SERVICE BULLETIN

N° 139-630

**ATA 46 – COMPLETION OF KIT PRIMUS EPIC® PHASE 8 SOFTWARE RELEASE
INSTALLATION**

AW139 helicopter S/N 31869.

Figure 13

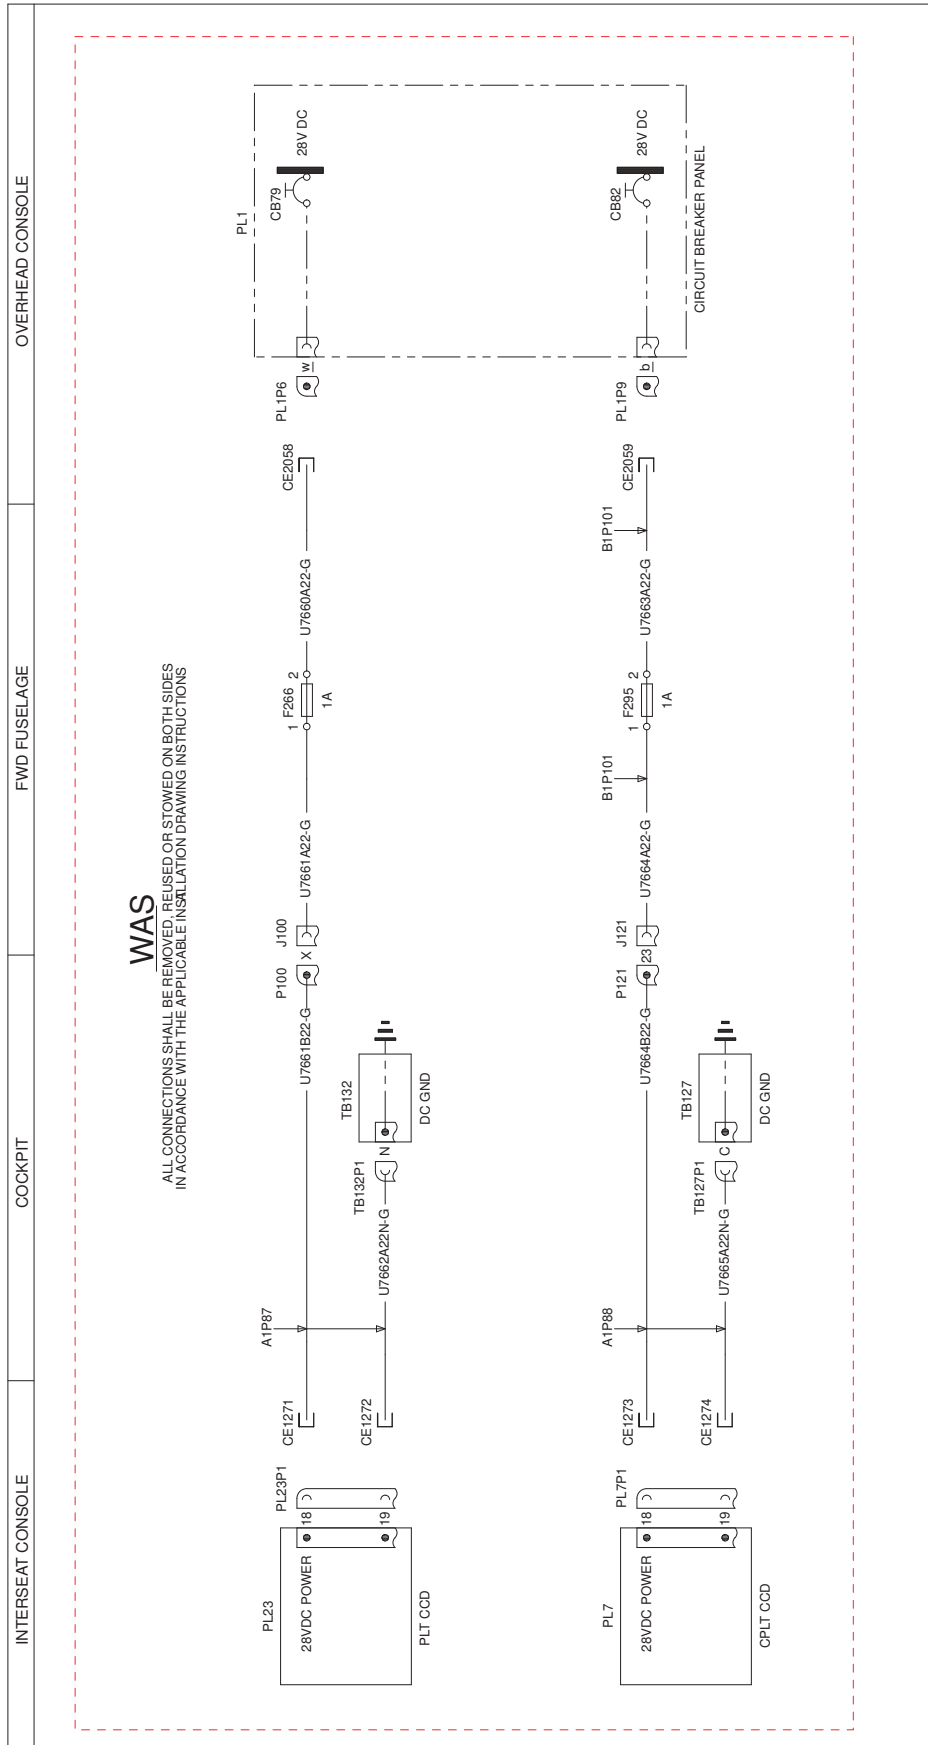
10. With reference to Figure 13, install the DLMU-W P/N G7229-012 on the interseat console and connect its connectors PL186P1 and PL186P3.
11. In accordance with AMP DM 39-A-11-00-01-00A-720A-A and with reference to Figure 13, install decal P/N ED300PL186 in an area adjacent to previously installed DLMU-W.

Figure 18

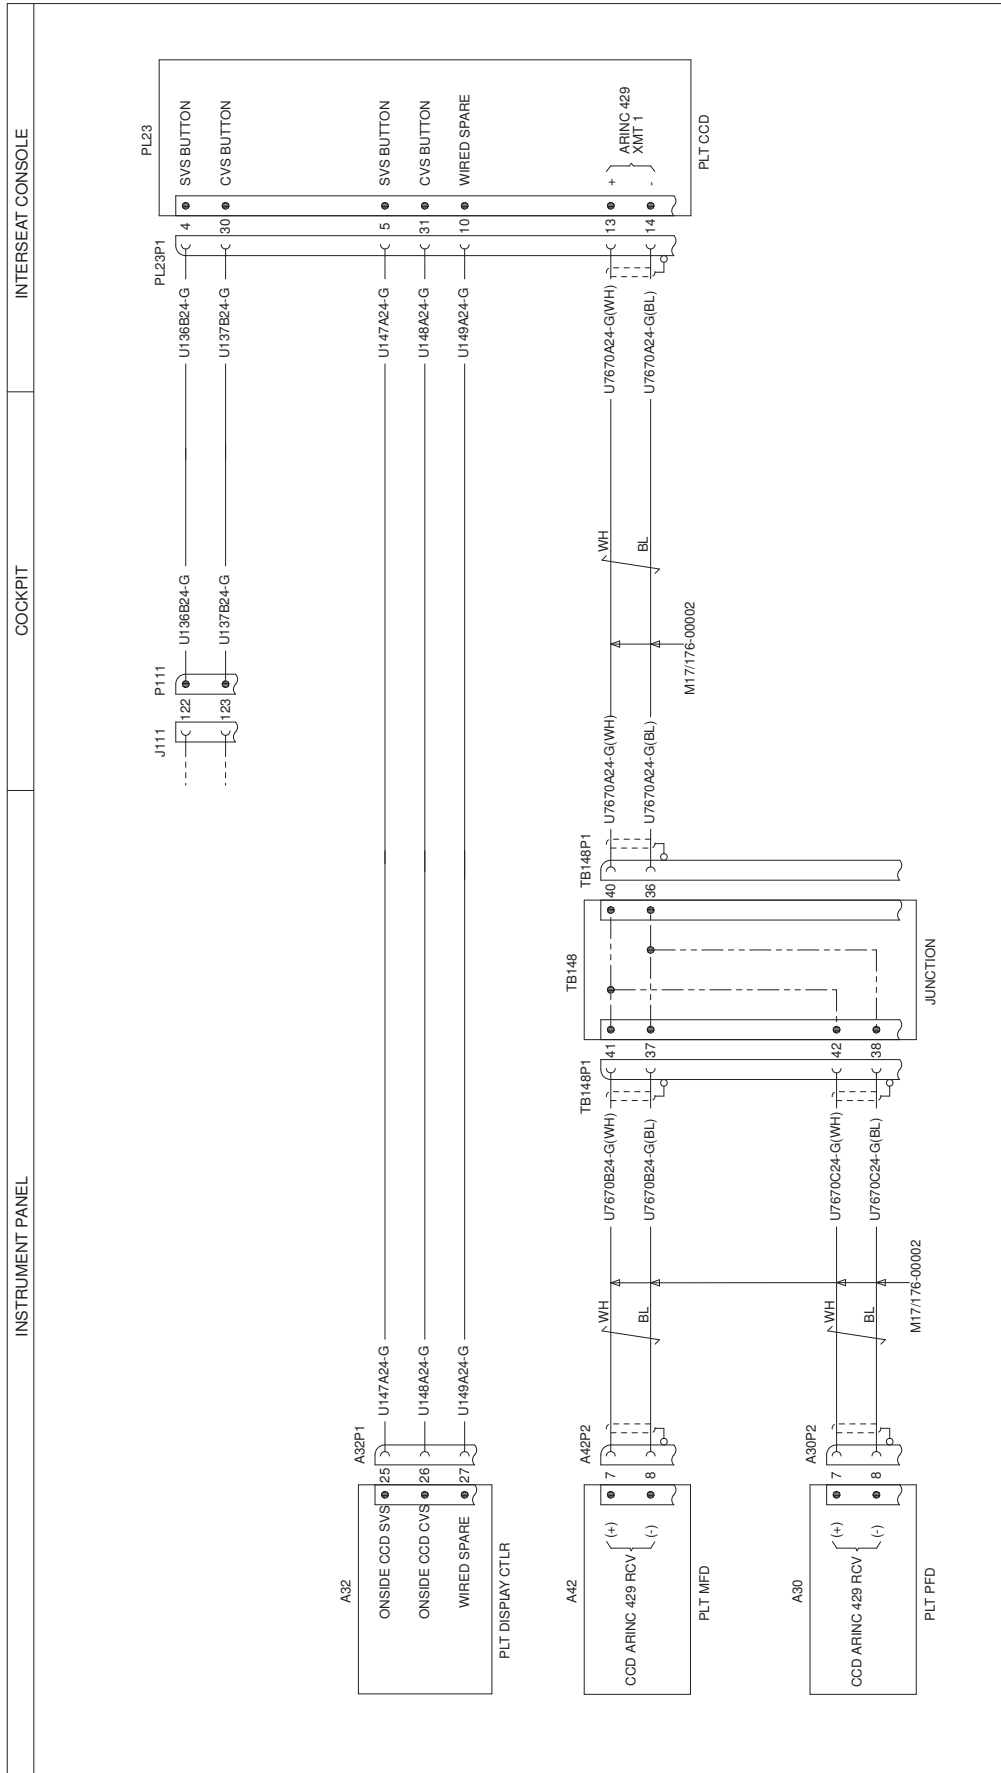
- 7.3 With reference to Figure 8 and Figures 18 wiring diagram (BECOMES), cut wire P/N A556A-T20 of adequate length and lay down between sectioning connector J100 pin U and fuse F266 following the existing route as shown.

- 7.4 In accordance with AMP DM 39-A-20-10-08-00A-622A-A and with reference to Figure 18 wiring diagram (BECOMES), crimp on wire electrical contact P/N M39029/56-352 (J100 side) and electrical contact P/N A523A-A02 (F266 side) by means of proper crimping tool.

- 7.5 In accordance with AMP DM 39-A-20-10-18-00A-691A-A and with reference to Figure 18 wiring diagram (BECOMES), mark wire as indicated by means of marker sleeves P/N A578A02-9.

- 7.6 With reference to Figure 18 wiring diagram, perform the electrical connection of wire ID U7801A20-G to pin U of sectioning connector J100 and to pin 1 of fuse F266.

- 7.9 In accordance with AMP DM 39-A-20-10-18-00A-691A-A and with reference to Figure 18 wiring diagram (BECOMES), re-mark wires as indicated by means of marker sleeves P/N A578A02-9.

Figure 21

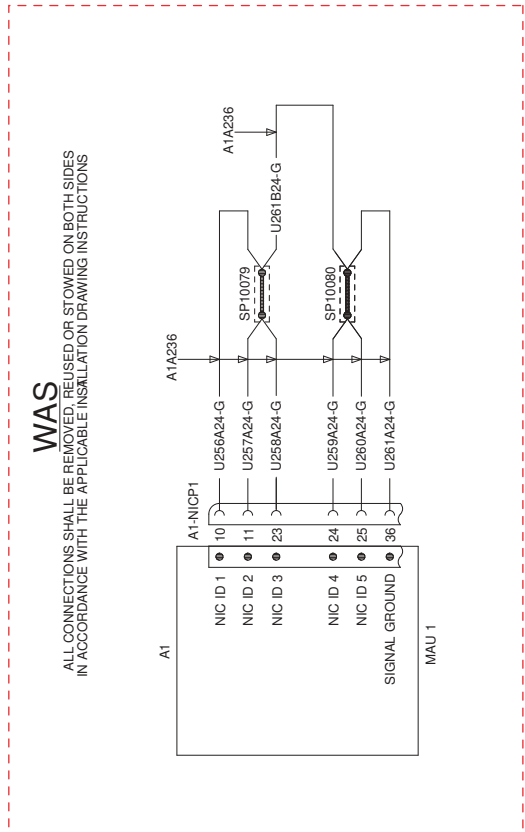
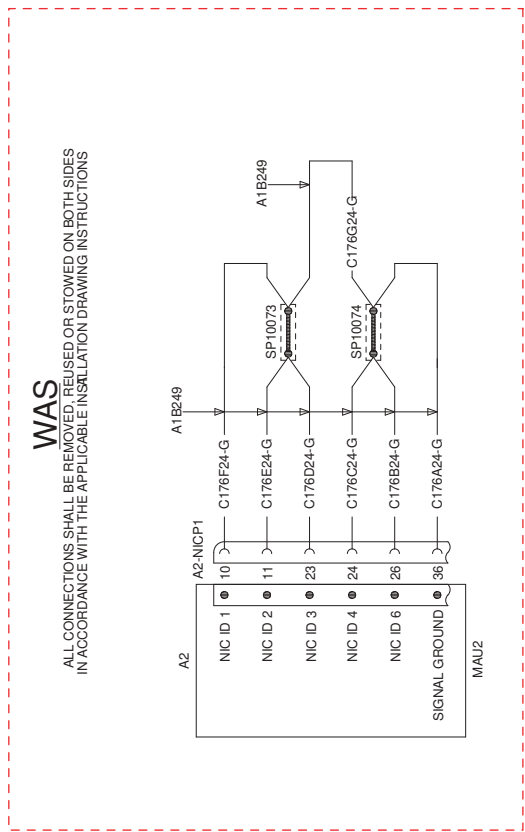
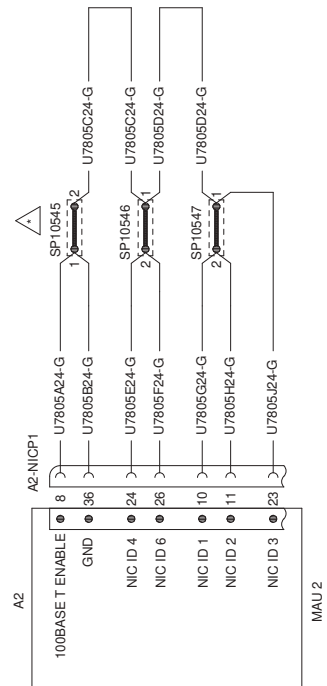
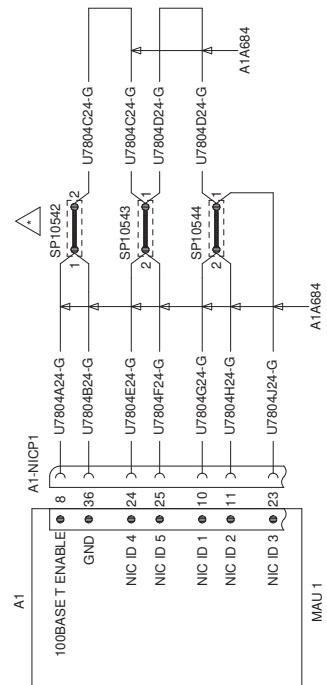
- 7.26 With reference to Figure 3 and Figure 21 wiring diagram, remove the electrical connections from MAU 1 connector A1-NICP1 as indicated and replaces as required. Use n°3 splices P/N M81824/1-1, n°7 electrical contacts P/N M39029/63-368 and wires P/N A556A-T24 as required. Mark wires as indicated by means of marker sleeves P/N A578A02-9.

- 7.27 With reference to Figure 2 and Figure 21 wiring diagram, remove the electrical connections from MAU 2 connector A2-NICP1 as indicated and replaces as required. Use n°3 splices P/N M81824/1-1, n°7 electrical contacts P/N M39029/63-368 and wires P/N A556A-T24 as required. Mark wires as indicated by means of marker sleeves P/N A578A02-9.

Figure 22

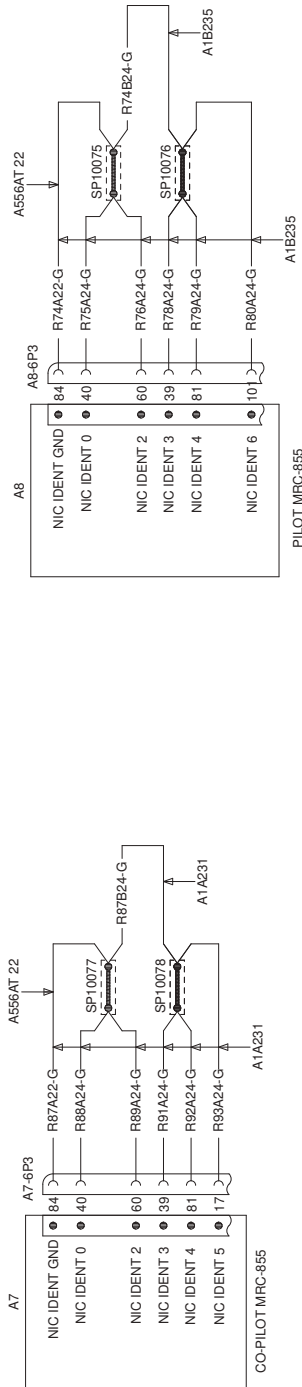
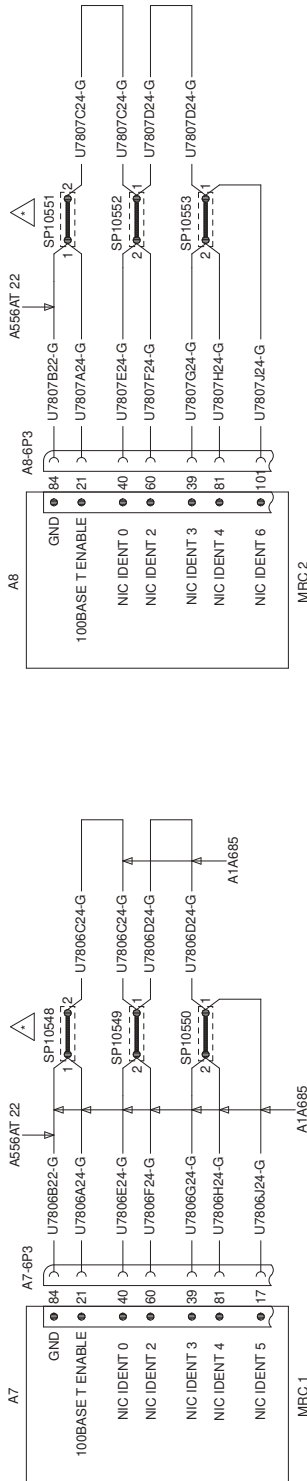
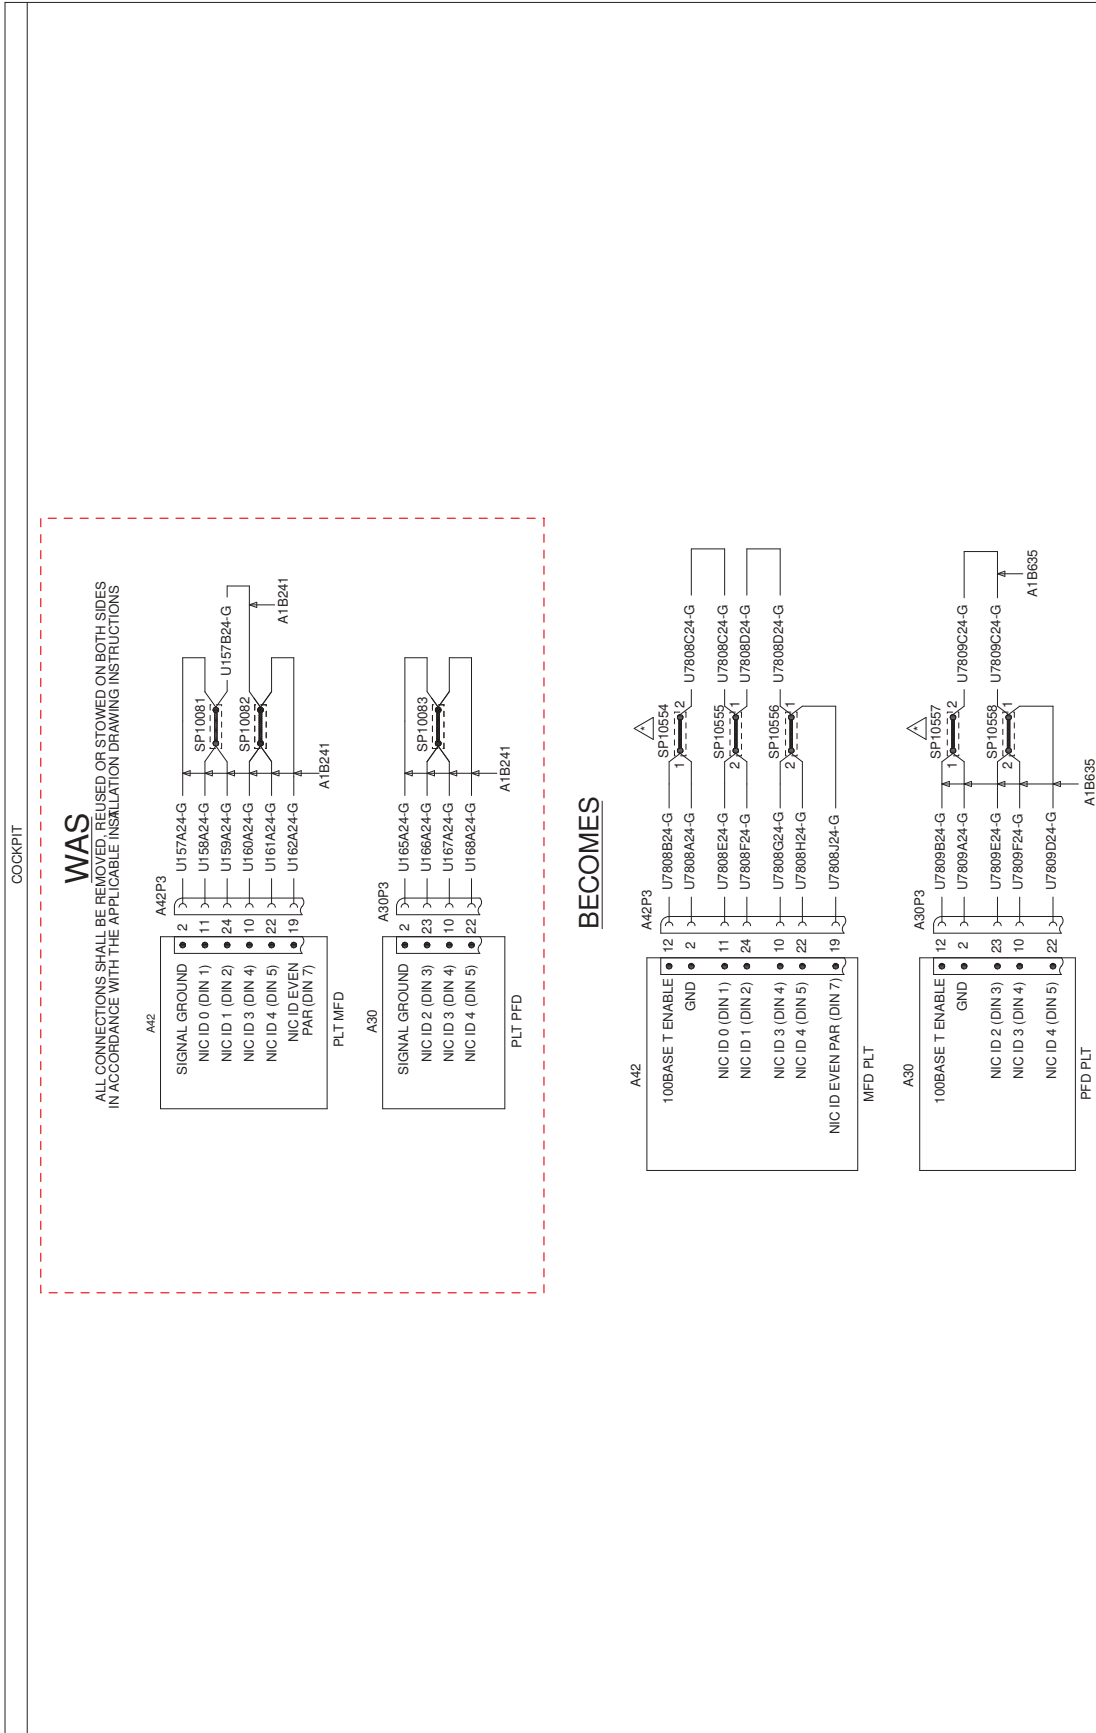
- 7.28 With reference to Figure 3 and Figure 22 wiring diagram, remove the electrical connections from MRC 1 connector A7-6P3 as indicated and replaces as required. Use n°3 splices P/N M81824/1-1, n°7 electrical contacts P/N M39029/57-354 and wires P/N A556A-T22 and P/N A556A-T24 as required. Mark wires as indicated by means of marker sleeves P/N A578A02-9.

- 7.29 With reference to Figure 2 and Figure 22 wiring diagram, remove the electrical connections from MRC 2 connector A8-6P3 as indicated and replaces as required. Use n°3 splices P/N M81824/1-1, n°7 electrical contacts P/N M39029/57-354 and wires P/N A556A-T22 and P/N A556A-T24 as required. Mark wires as indicated by means of marker sleeves P/N A578A02-9.

Figure 23

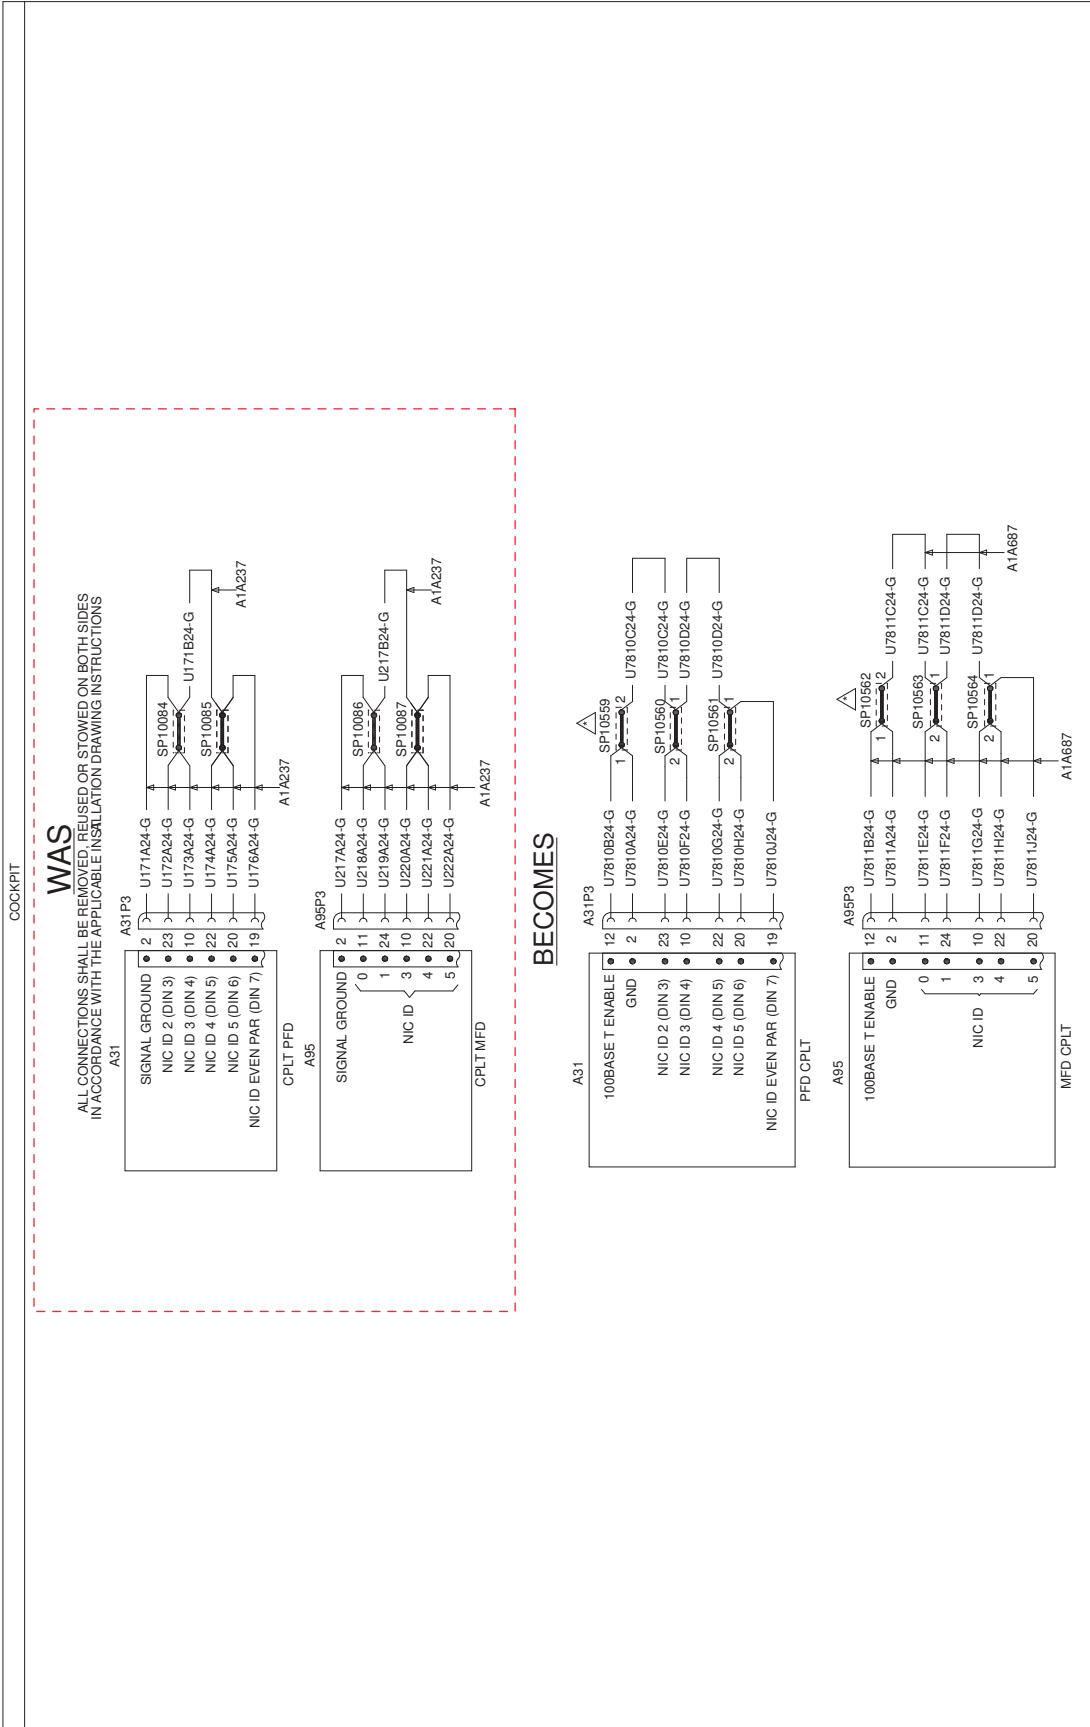
- 7.30 With reference to Figure 4 and Figure 23 wiring diagram, remove the electrical connections from MFD PLT connector A42P3 as indicated and replaces as required. Use n°3 splices P/N M81824/1-1, n°7 electrical contacts P/N M39029/63-368 and wires P/N A556A-T24 as required. Mark wires as indicated by means of marker sleeves P/N A578A02-9.

- 7.31 With reference to Figure 4 and Figure 23 wiring diagram, remove the electrical connections from PFD PLT connector A30P3 as indicated and replaces as required. Use n°2 splices P/N M81824/1-1, n° 5 electrical contacts P/N M39029/63-368 and wires P/N A556A-T24 as required. Mark wires as indicated by means of marker sleeves P/N A578A02-9.
